**Subject: Vermont Yankee Nuclear Power Station
License No. DPR-28 (Docket No. 50-271)
Technical Specifications Proposed Change No. 258
RPV Fracture Toughness and Material Surveillance Requirements**

Proposed Technical Specification Change No. 258

RPV Fracture Toughness and Material Surveillance Requirements

VYNPS
FIGURE 3.6.1

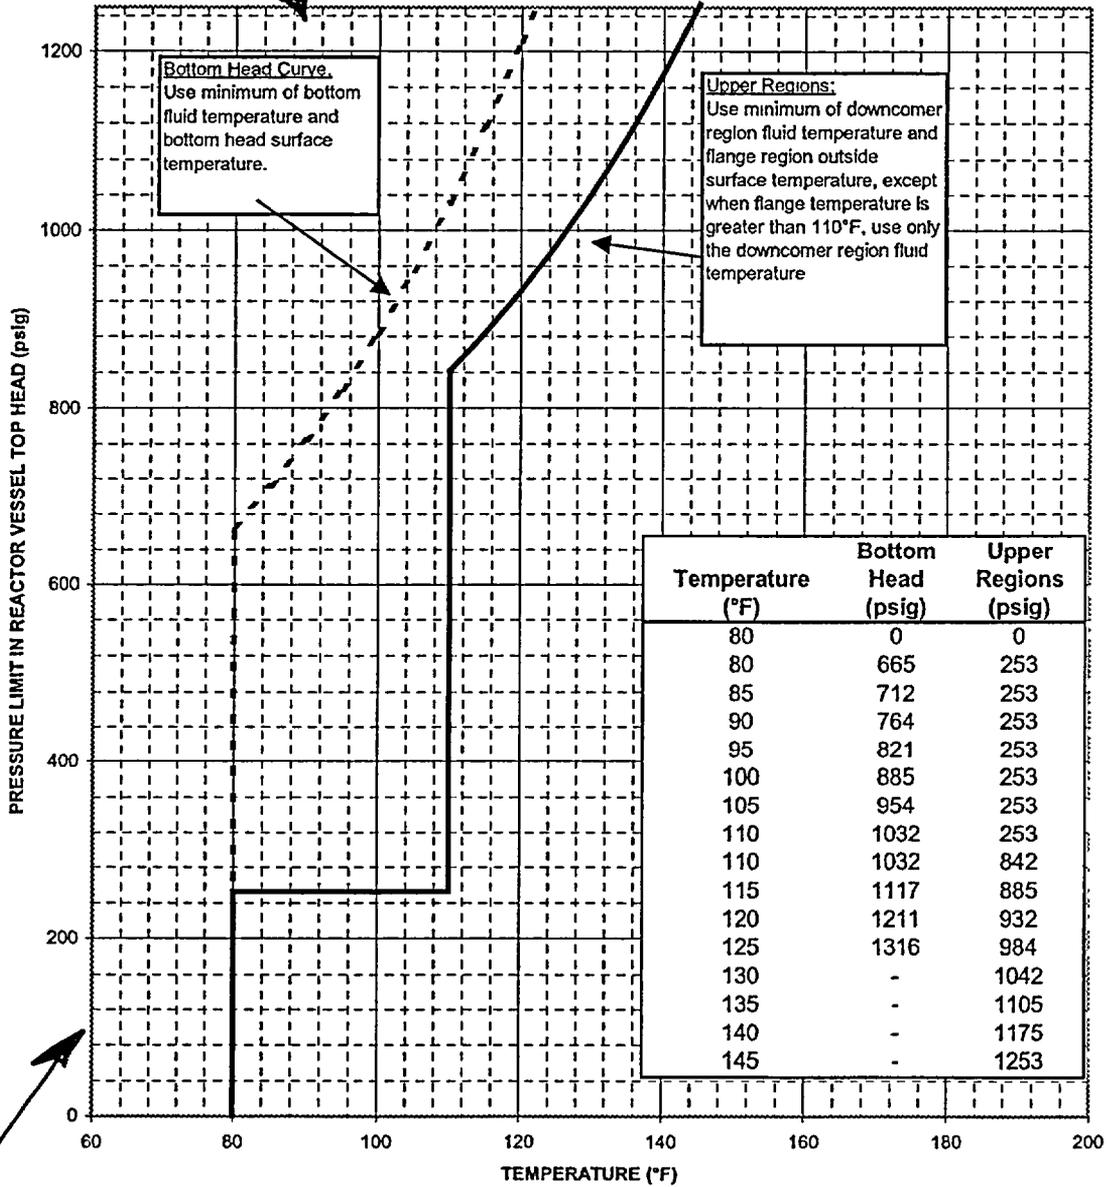
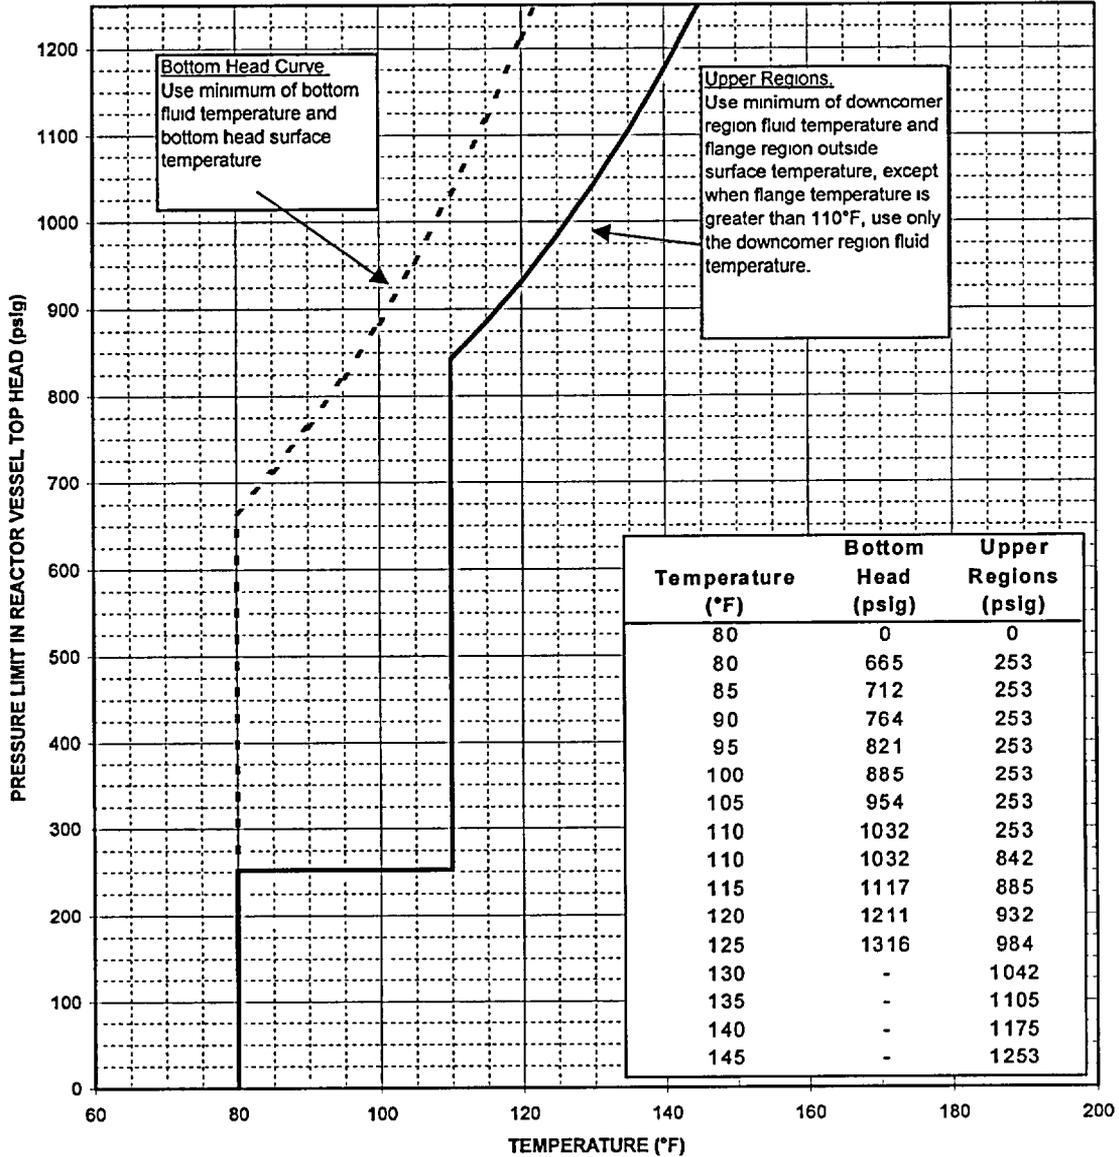
- Figures 3.6.1, 3.6.2 and 3.6.3 currently contain a statement that each is valid through the end of Cycle 23. That validity duration is being changed to 4.46×10^8 megawatt-hours thermal (MWH(t)).
- To improve legibility of the curves, the grid line divisions have been changed, the ordinate axis has been identified by 100 psi increments, and more data were used to plot the curves to improve resolution.
- A Note is being added to TS Figure 3.6.2 to specify requirements for minimum temperature when using local test instrumentation during flange tensioning and detensioning operations. The new Note will specify:

For the hydrostatic pressure and leak test curve (TS Figure 3.6.1), a coolant heatup and cooldown temperature rate of 40°F/hr or less must be maintained at all times. Similarly, for the normal operation, core not critical (TS Figure 3.6.2) and the normal operation, core critical curve (TS Figure 3.6.3), the P-T curves specify a coolant heatup and cooldown temperature rate of 100°F/hr or less for which the curves are applicable.

The change to TS Figures 3.6.1, 3.6.2 and 3.6.3 to extend their applicability to 4.46×10^8 MWH(t) corresponds to an integrated plant operation of 32 EFPY. This limitation is acceptable because it is based on the re-calculated, expected neutron fluence over 40 years of operation at the current licensed power level, accounting for periods of downtime.

CHANGE GRID LING DIVISIONS AND USE MORE DATA TO PLOT CURVES

40°F/hr Heatup/Cooldown Limit
Valid Through 4.46E8 MWH(t)

FIGURE 3.6.2

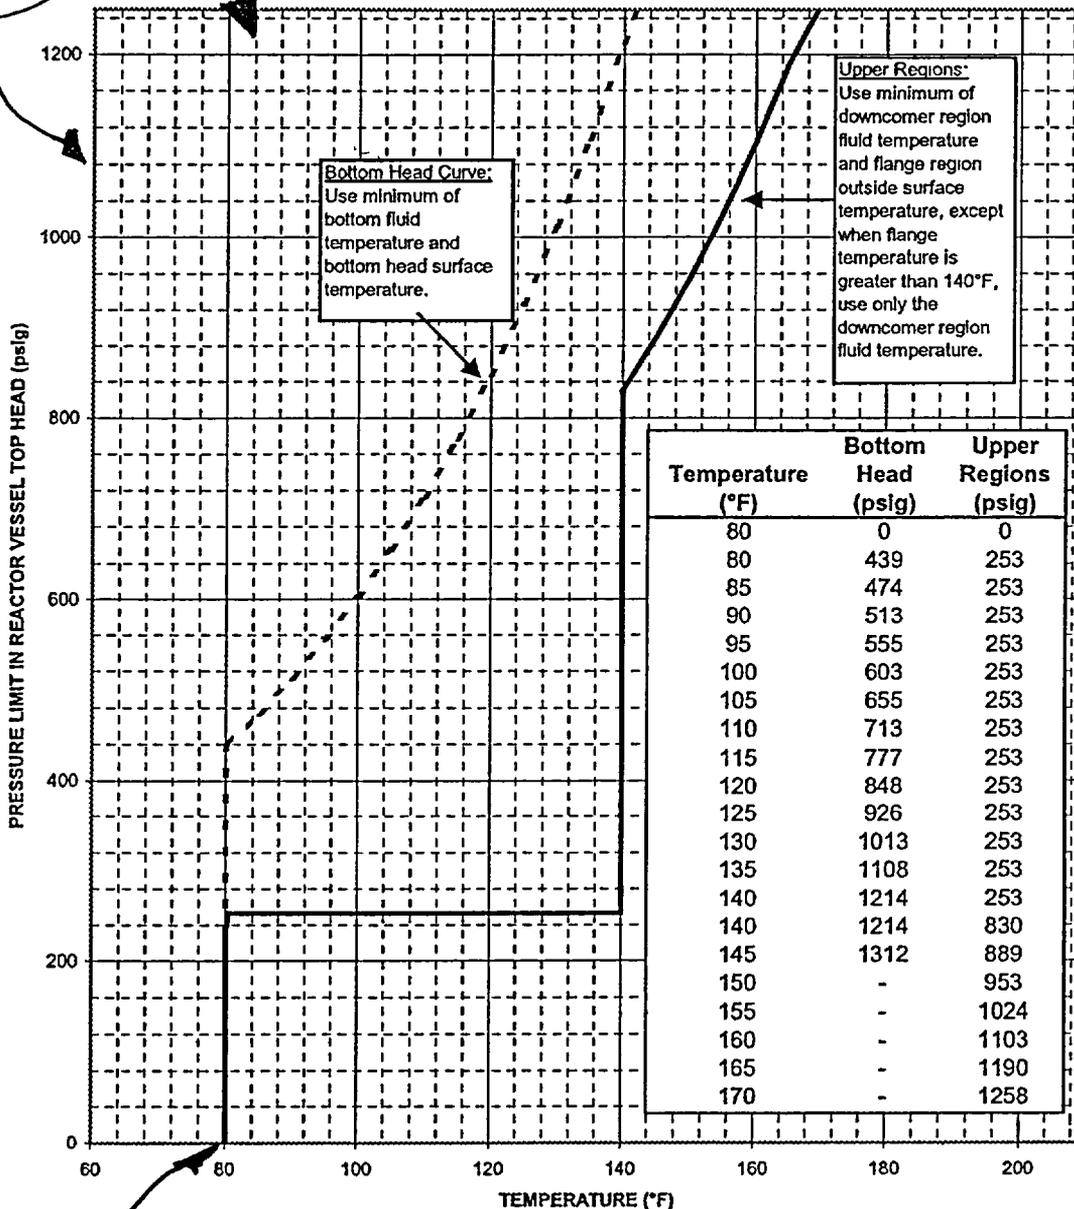
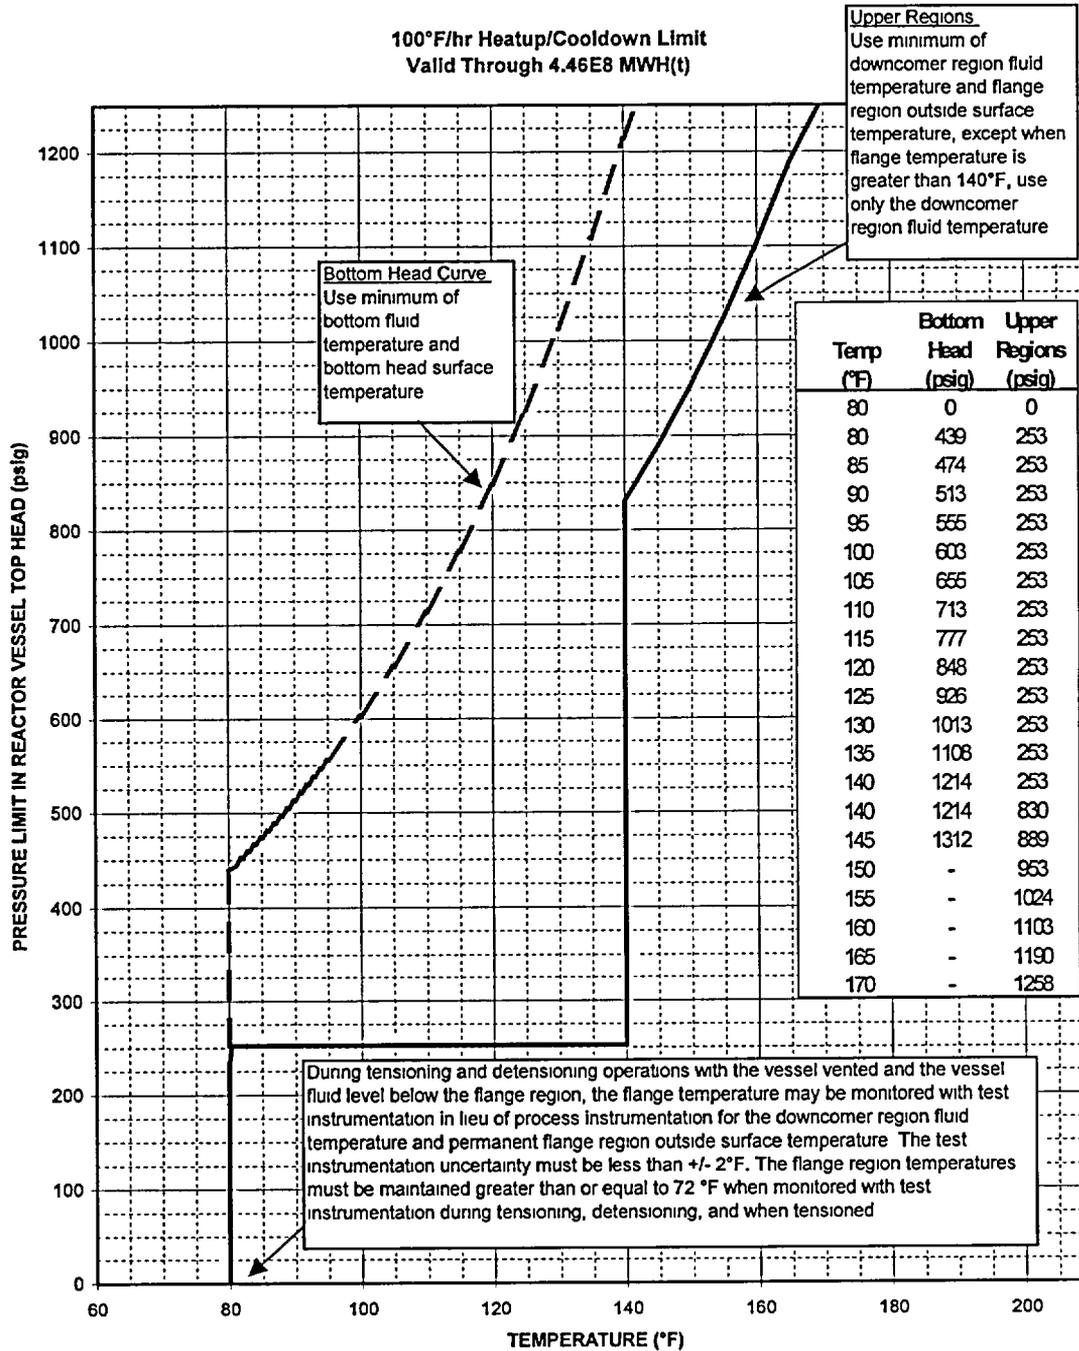
The addition of a Note to TS Figure 3.6.2 to permit use of test instrumentation during tensioning, detensioning, and when tensioned is acceptable because test instrumentation can provide a better method of monitoring bolt-up temperatures during this phase of operations. The use of such instrumentation is limited to the condition when the vessel is vented and vessel fluid level is below the flange region. The establishment of this condition ensures that the vessel cannot be pressurized while relying on test instrumentation. Because test instrumentation is more accurate (conservatively within +/- 2°F) than permanent temperature instrumentation (+/- 10°F), a limit of $\geq 72^\circ\text{F}$ may be established when using test instrumentation. A 72°F limit for test instrumentation corresponds to an 80°F limit for permanent temperature instrumentation when the respective instrumentation uncertainties are included. These values are acceptable because the analytical limit for head bolt-up is 70°F (without instrument uncertainty) as stated in current TS 3.6.A.

A Note is included in Figure 3.6.2 that specifies test instrumentation uncertainty must be +/- 2°F and the flange region temperatures must be maintained greater than or equal to 72°F when using such instrumentation in lieu of permanently installed instrumentation. Qualified test instrumentation may only be used for the purpose of maintaining the temperature limit when the vessel is vented and the fluid level is below the flange region. If permanently installed instrumentation (with a 10°F uncertainty) is used during head tensioning and detensioning operations, the 80°F limit must be met.

100°F/hr Heatup/Cooldown Limit
Valid Through End of Cycle 23

4.46 EB MWH(ε)

SHOW 100 PSIG INCREMENTS ON ORDINATE AXIS

100°F/hr Heatup/Cooldown Limit
Valid Through 4.46E8 MWH(t)

FIGURE 3.6.3

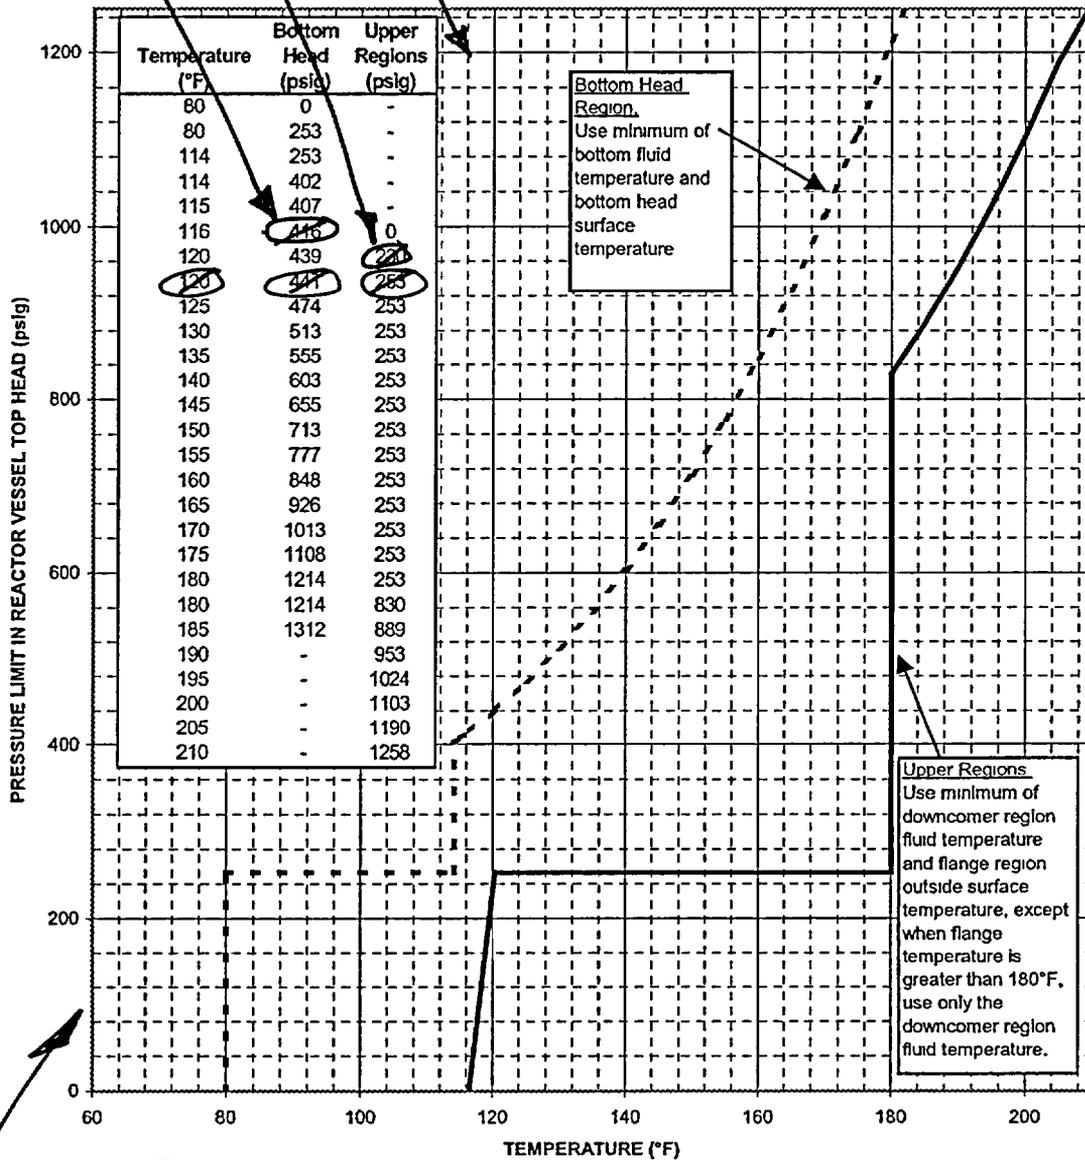
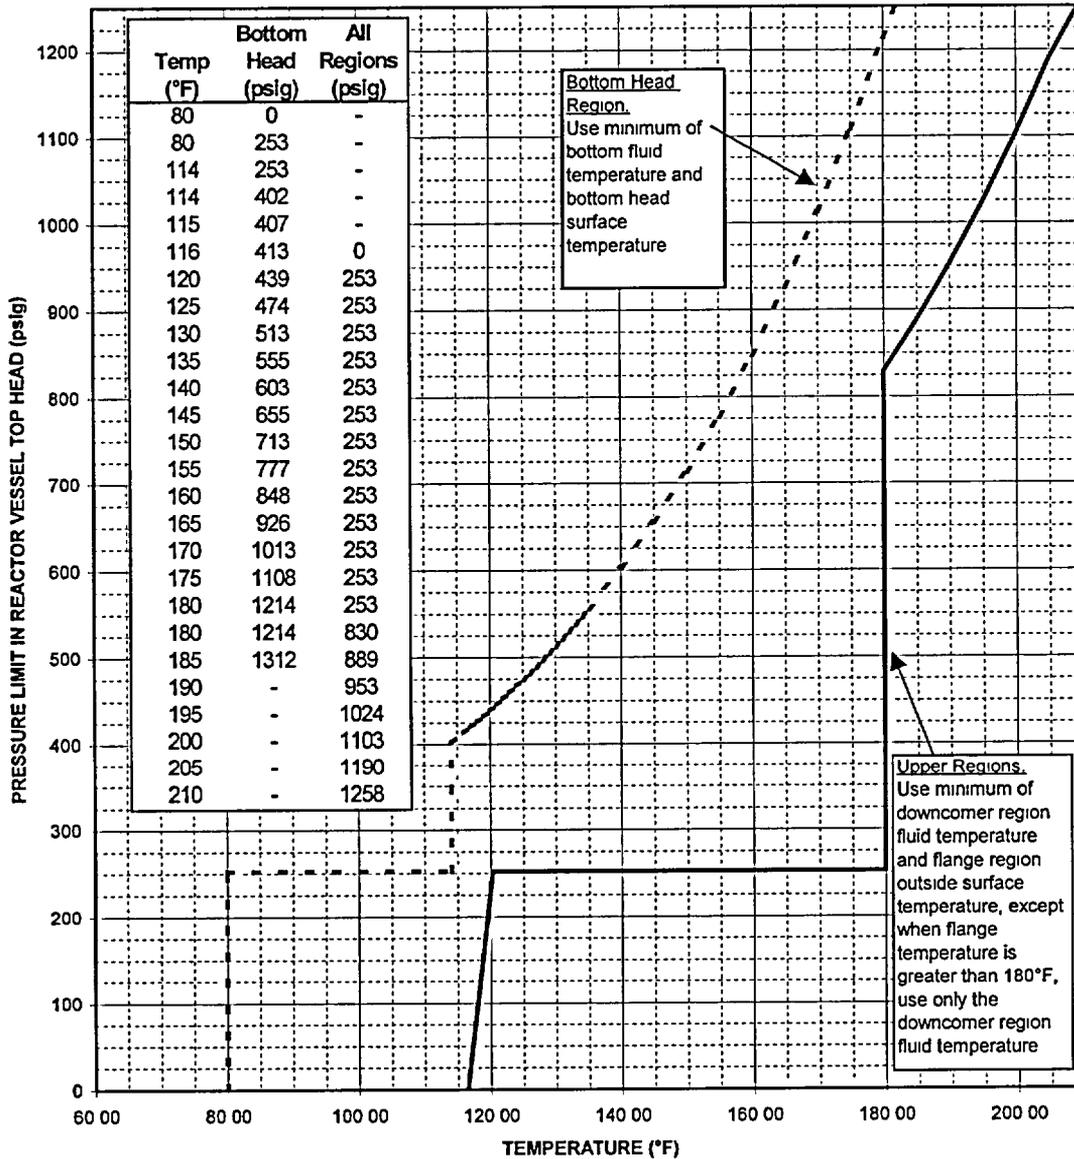
- The tabulation of pressure and temperature data on Figure 3.6.3 is being revised to more accurately reflect the plot of the curves (the curves are unchanged). At 116°F the bottom head pressure is changed to 413 psig, instead of the current 416 psig. At 120°F, there should be only two data points on Figure 3.6.3, and these are at 253 psig for the upper region and at 439 psig for the bottom head region. Therefore, the tabulation corresponding to a temperature of 120°F will only specify pressures of 439 psig and 253 psig for the bottom head region and upper region, respectively.

The changes to the tabulation in Figure 3.6.3 represent a correction of actual values used to generate the current curves. The current tabulation indicates that four different pressure limits were established corresponding to a temperature of 120°F. As can be seen from the curves, there are only two such points for 120°F. Similarly, the change in bottom head pressure at 116°F to 413 psig reflects a past administrative error in transcribing the actual value from the current curve. These changes to correct the tabulation are acceptable because they do not change actual limits (the curves are unchanged) and reflect the outputs from previous analyses.

If Pressure < 253 psig, Water Level must be within Normal Range for Power Operation
Valid Through End of Cycle 23

4.46 EB MWH(E)

SHOW 100 PSE INCREMENTS ON ORDINATE AXIS

100°F/hr Heatup/Cooldown Limit
If Pressure < 253 psig, Water Level must be within
Normal Range for Power Operation
Valid Through 4.46E8 MWH(t)
